Source: Prestolite Leece-Neville Heavy Duty Systems
Bulletin No: TSB-1238 **Date:** January 8, 2024
Models: A0014861JB
Subject: Terminal identification to A0014868JGH

Terminal identification to replace A0014861JB ignition excite alternator with A0014868JGH self-excite alternator.

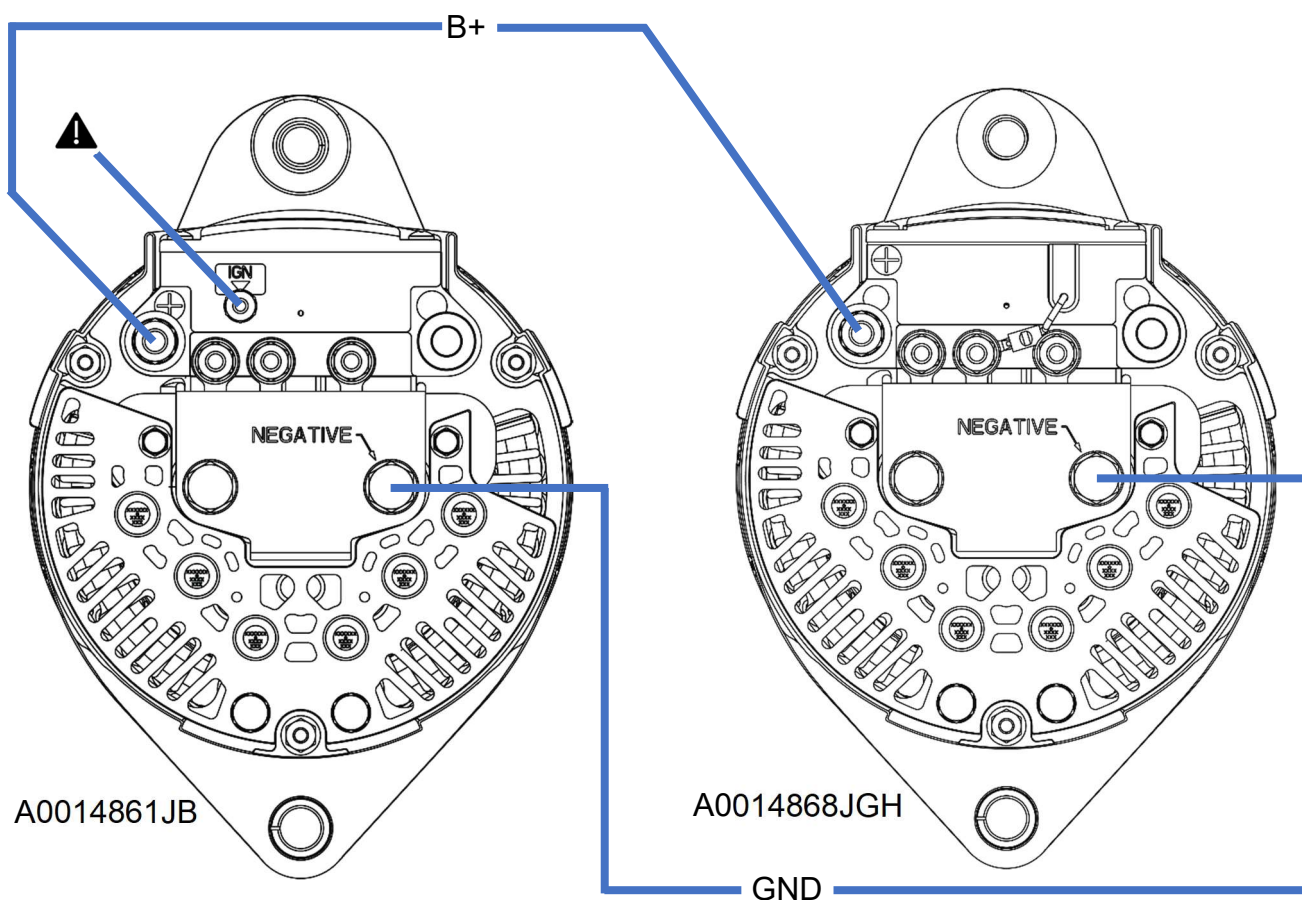
! Ignition connection on A0014861JB is not required on A0014868JGH.
Insulate and secure this wire to prevent shorting, as it is not a necessary connection for the A0014868JGH.
